Te Kuha Opencast Mine - Geochemistry Review

Department of
Conservation
Te Papa Atawhai

O'Kane
Consultants

994-1-1

Figure 5.1: Proposed infrastructure for the Te Kuha Coal Mine – Year 1

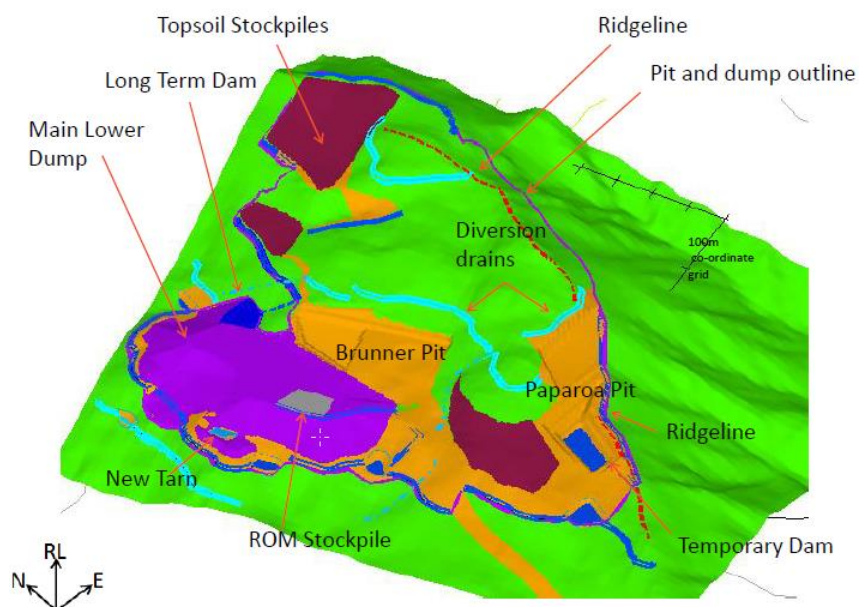
- A clear mining schedule is needed, which should be linked to the volumes of each geochemical type of waste rock that will be placed in each dump such that NAF PCM and BCM can be separated and re-handled appropriately. The development of the waste rock dump design and schedule should be linked to the preliminary waste rock block model. This should be updated as more geochemical and geological data become available through an adaptive management process. CRL Energy Limited (2015) note that a plan of the temporary waste rock dumps should be completed, which presumably relates to such matters. This needs to be reviewed.

- Explanation is required on how the Main Lower WRD will be lined with NAF PCM and for what purpose.
- Clarification is required as to the process of progressive rehabilitation followed by subsequent re-handling of this material. It seems onerous to undertake rehabilitation activities and then dig it up.

- Traffic management and QA/QC processes will need to be developed to ensure the correct placement of waste rock within the ex-pit WRDs and the backfill.

Figure 6.1: Scenario 1 Zn water quality predictions for proposed compliance points for West Creek and Camp Creek

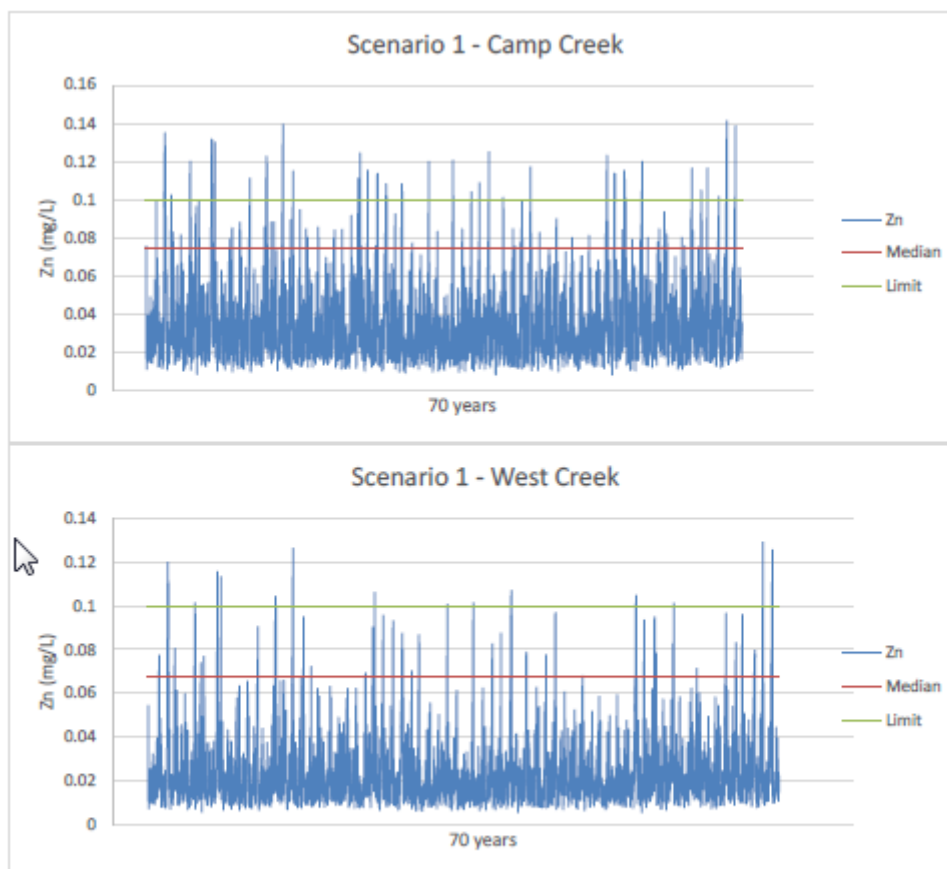
- CRL indicates that Fe concentrations are likely to be low in site leachate waters based on data from the field column leach tests. However, the field column leach tests were conducted under oxidising conditions. It is proposed that the waste rock dumps at Te Kuha will be built in ~5m lifts to minimise grainsize segregation and chimney effects which will minimise oxygen ingress and thus parts of the WRD will be low in oxygen and Fe^{2+} could thus remain in solution. Consideration of this is required for operational and longer-term water management.

- CRL Energy Limited (2016) indicate that Ni, Zn, and Mn remain dissolved and are likely to remain dissolved through neutralisation to pH~7. Such matters require consideration for both operation management and management after closure in the longer term. Modelled Zn concentrations based on Scenario 1 are presented below in Figure 6.1 and are greater than potential discharge limit of 0.1 mg/L Zn (CRL Energy Limited, 2016).
